Dogger Bank South Offshore Wind Farms Project

PINS Reference: EN010125

Dogger Bank South Offshore Wind Farms Project – Notification of Intention to Submit a Change Request related to works in the Onshore Substation Zone (Change Request 2).

DRAWING TITLE
SUBSTATION ZONE CO-LOCATED HVDC OPTION
INDICATIVE SUBSTATION GENERAL
ARRANGEMENT

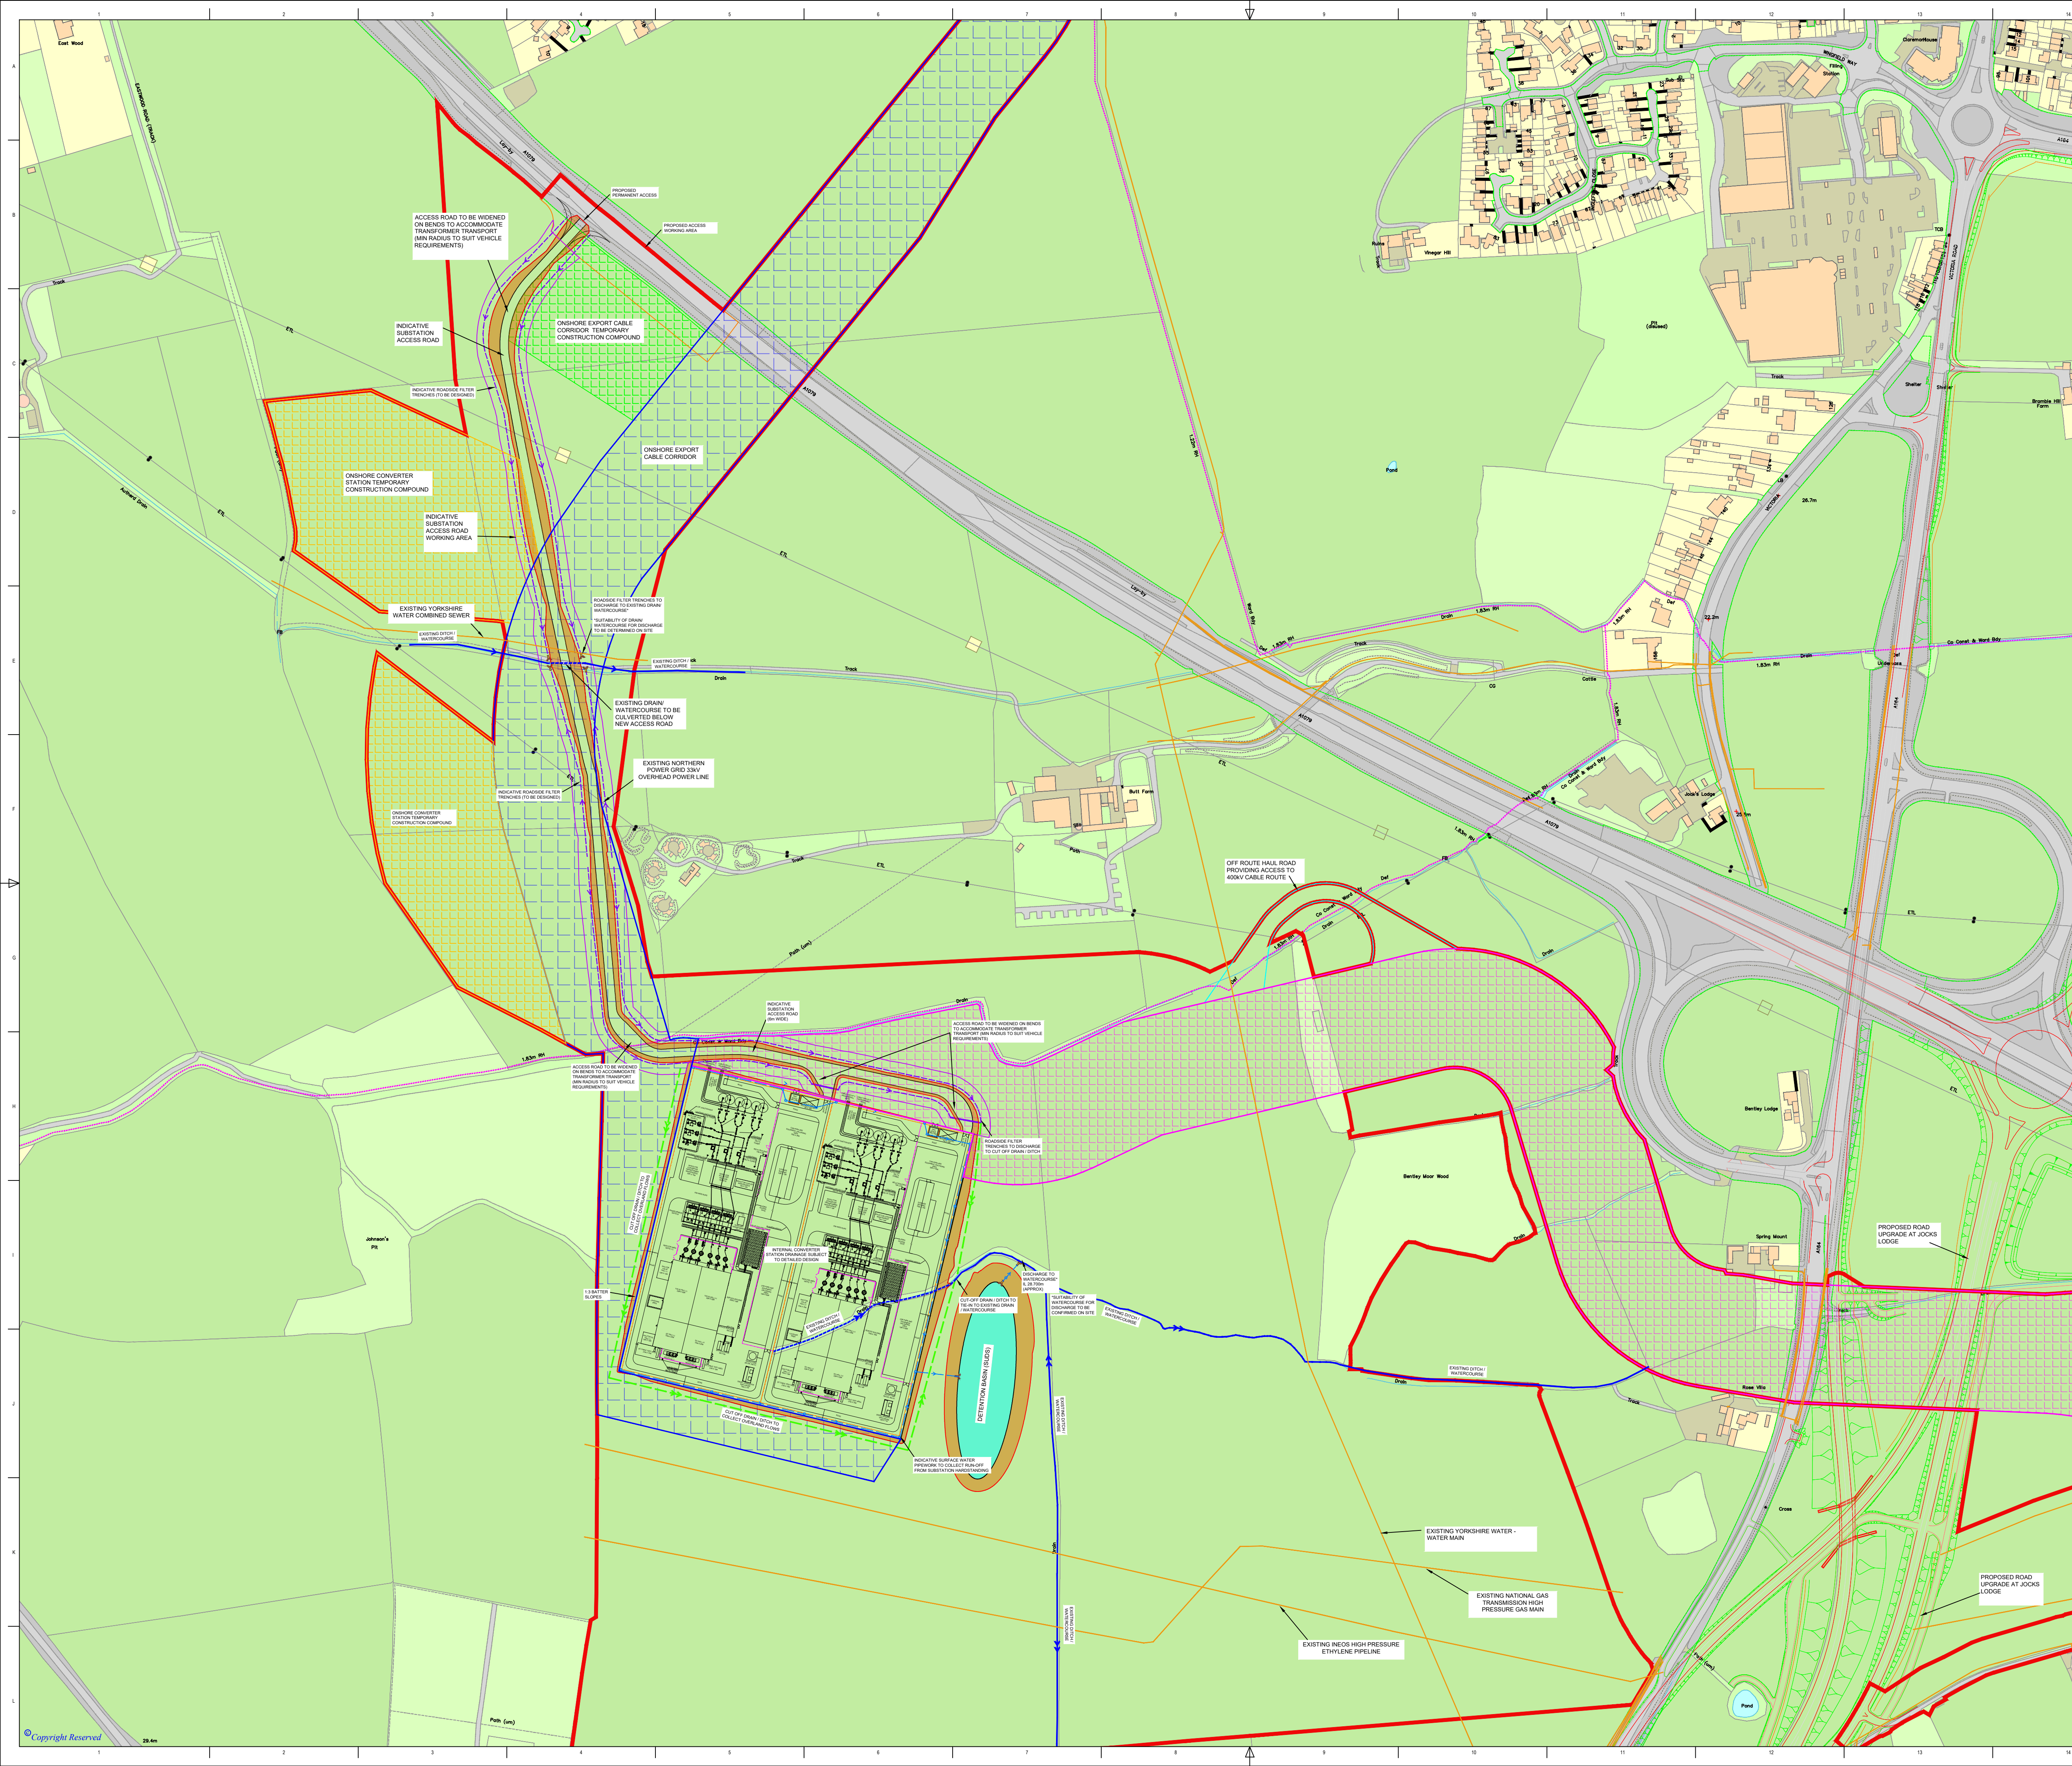
The reduction in area required for the Onshore Converter Station(s) would create enough space to move the Sustainable Drainage (SuDs) basin, located on **Appendix 5-3 Engineering Drawings** [APP-075], westward and avoid the

The maximum design parameters for the Projects Onshore Converter Station(s) have reduced, as outlined in Table 1. Whilst the scale of permanent infrastructure has reduced, it would be focused in the location outlined in Figure 1 of Appendix A which remains within Works No. 25A, located on page 18 of the **Works Plans (Onshore) (Revision 3)** [PDA-003]. This was assessed within the ES as the location for the construction and operation of the DBS East Project Onshore Converter Station.

Title:
Indicative Landscape Plan

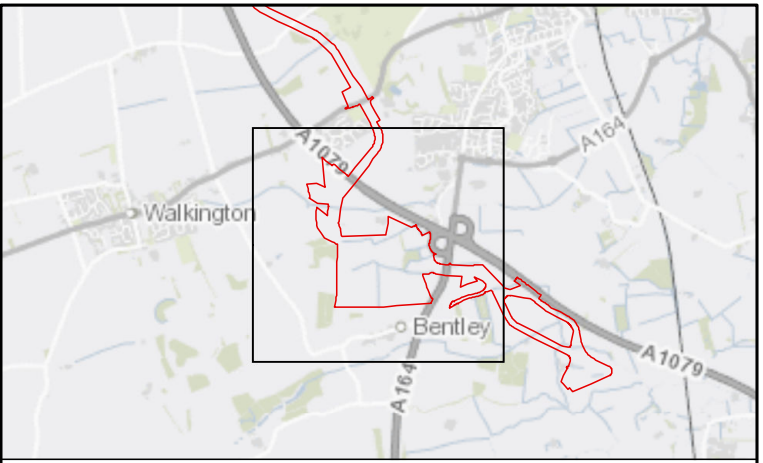
This update is necessary due to the reduced footprint of the Onshore Converter Station(s) which has led to minor adjustments to the landscape screening. These changes reflect the decreased built form during operation and accommodate the Yorkshire Water asset which traverses the Onshore Substation Zone. It also provides the opportunity for the Projects to address the feedback from ongoing discussions with the East Riding of Yorkshire Council and landowners regarding landscaping and minimising land-take. Landscape and Visual effects of the change from viewpoints 1-4 located within 1km of the Onshore Converter Station(s), as shown on **Figure 23-2 Onshore Substation Zone of Theoretical Visibility** [APP -193] are anticipated to be broadly positive due to a reduction in the built form. However, no materially new or different effects are anticipated.

Updates to the **Outline Landscape Management Plan** [APP-236] and **Figure 23-6 Indicative Landscape Plan (Revision 2)** [PDA-010] would be required once accepted by the ExA into Examination.

The reduction in the space required for the Onshore Converter Station(s) also enables a reduction in the area of permanent land use change within the Onshore Substation Zone, as shown on Figure 2 of Appendix A. This would enable the Projects to reduce the nature of the compulsory acquisition powers being sought in the **Draft DCO** [APP-027] for some of the area around the Onshore Converter Station(s), which is in line with previous stakeholder feedback and representations received from Albanwise Ltd [RR-001]. Further details of the changes to downgrade the compulsory acquisition powers will be included in the consultation material, as set out in section 4 of this letter.

Title:
Onshore Substation Zone

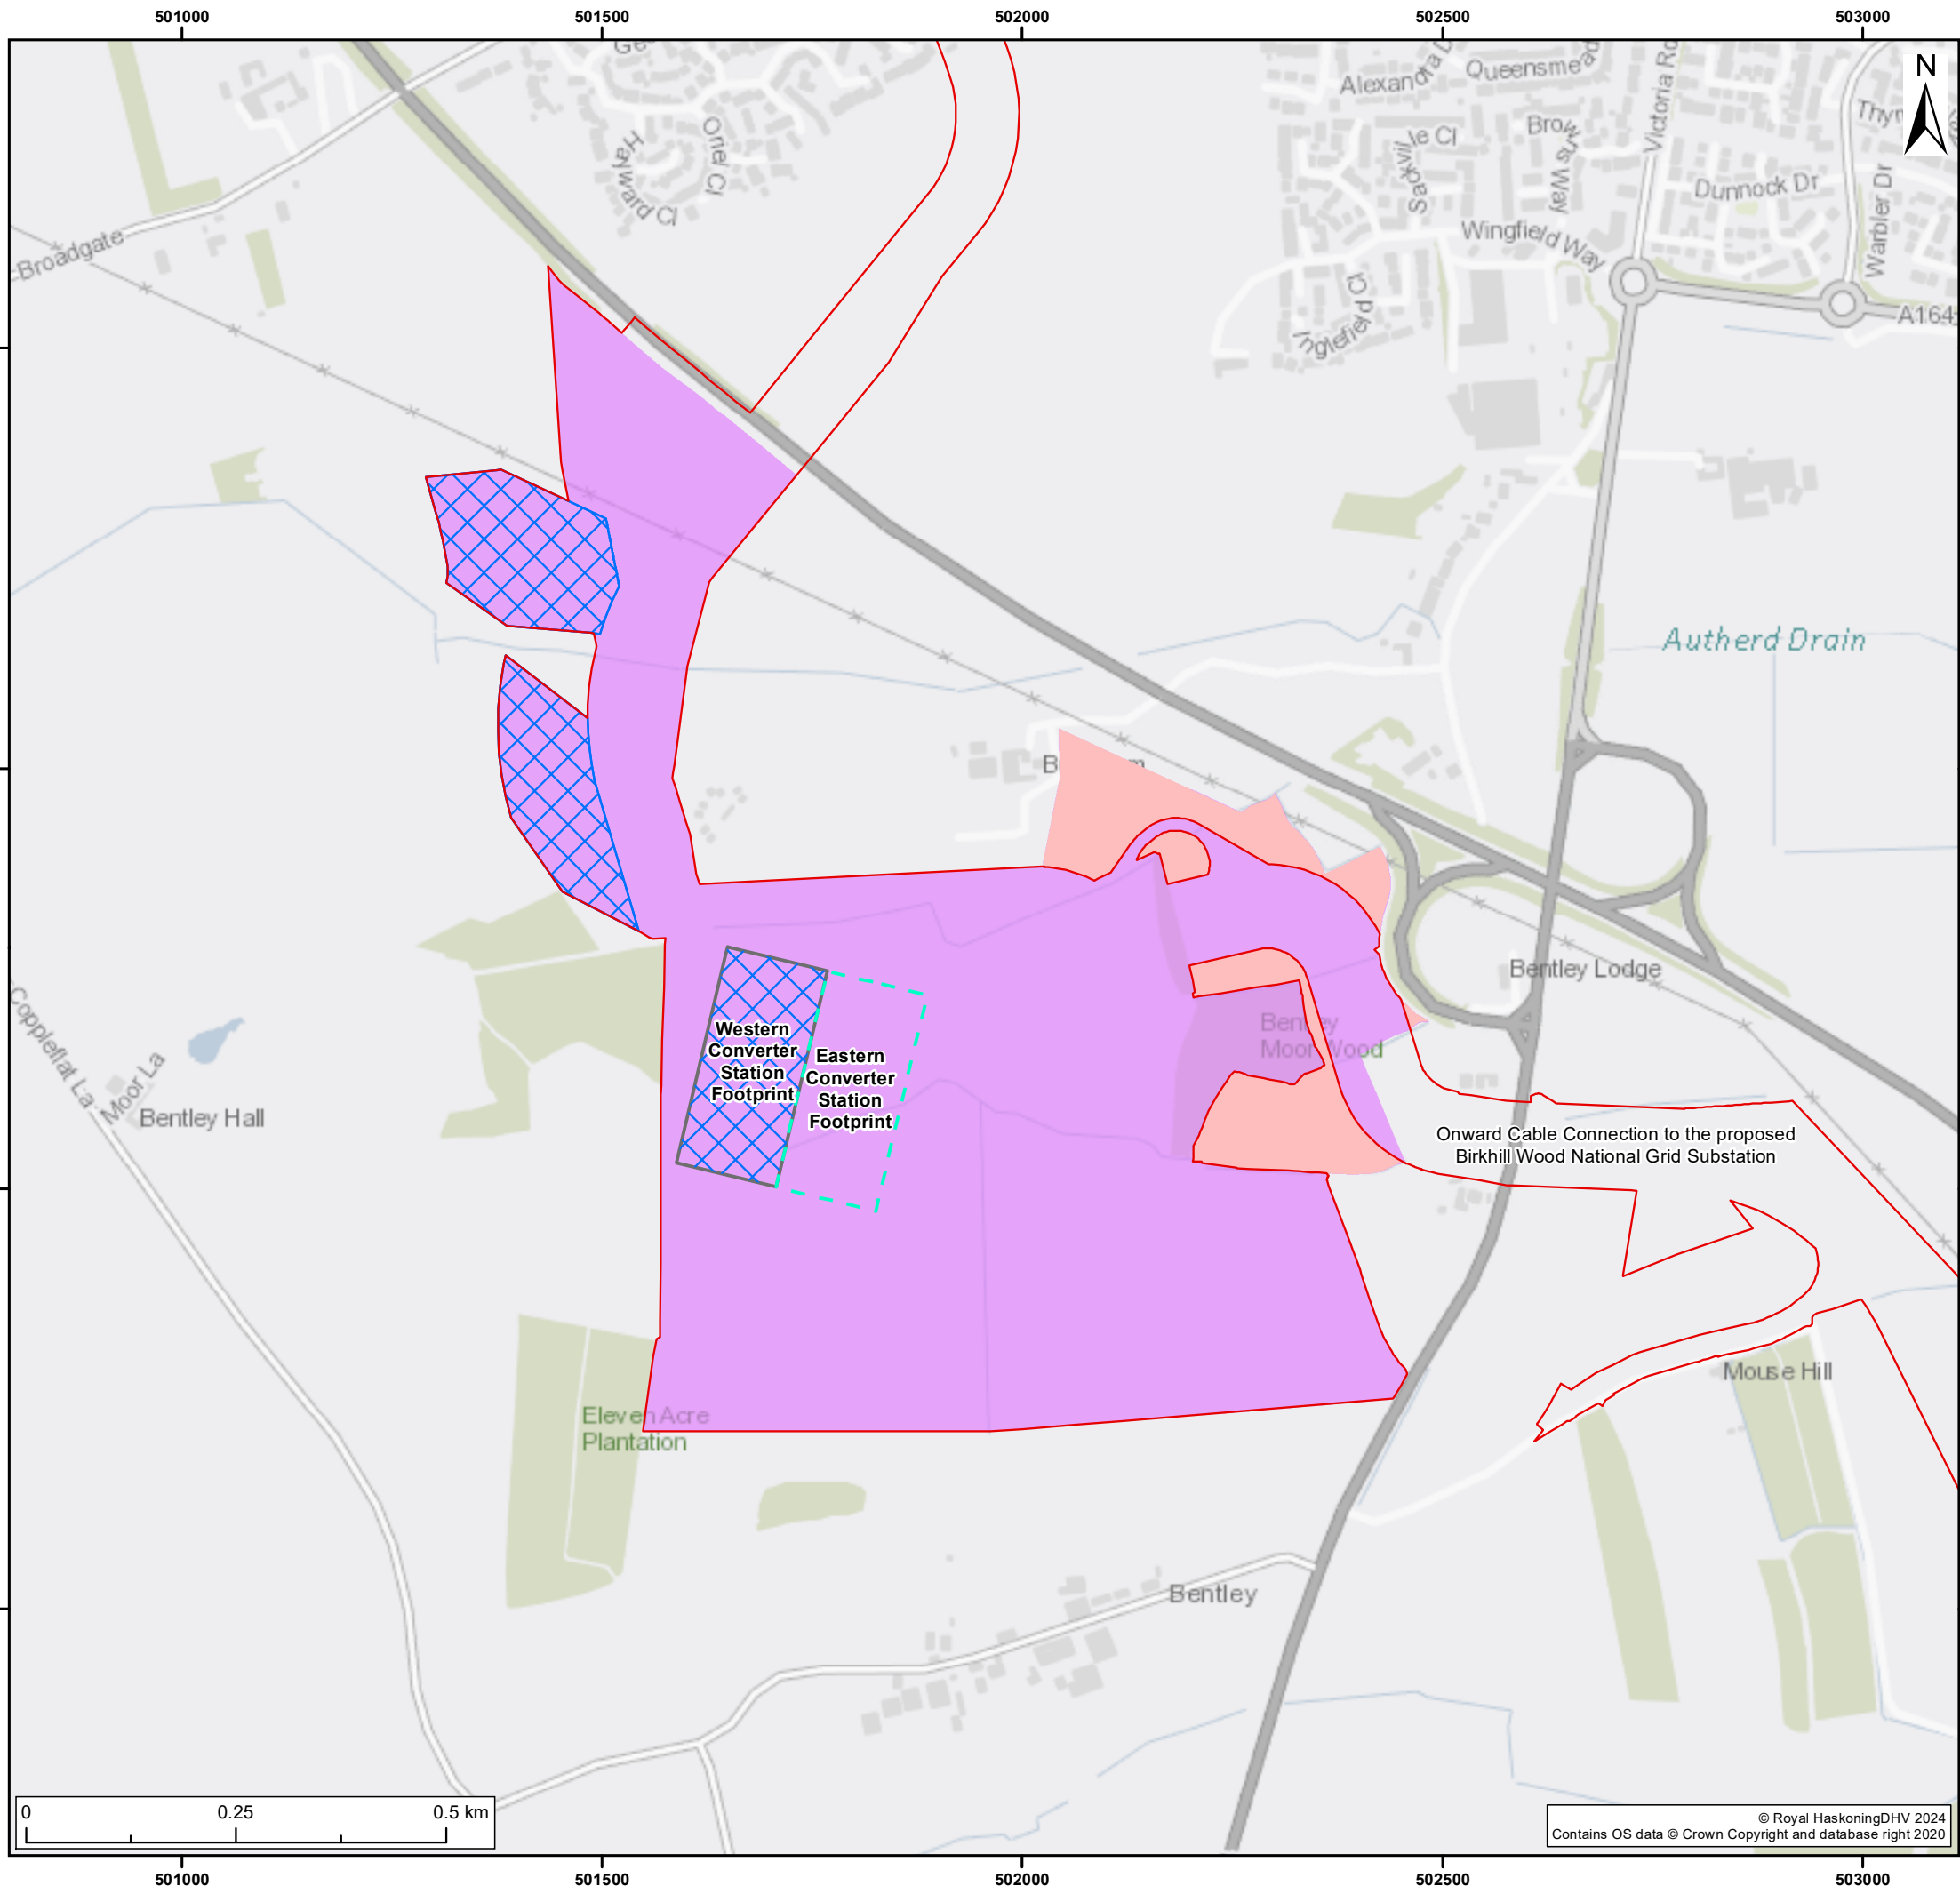
potential diversion of a Yorkshire Water asset that traverses the Onshore Substation Zone in proximity to the Bentley Moor Wood Ancient Woodland. As the potential Yorkshire Water diversion would no longer be required land in the north-east of the Onshore Substation Zone, Works No. 28A/B (Utility Connection Works) on Sheet 18 of the **Works Plan (Onshore) (Revision 3)** [PDA-003], can be removed from the Order Limits. Figure 3 shows the area proposed to be removed from the Order Limits.
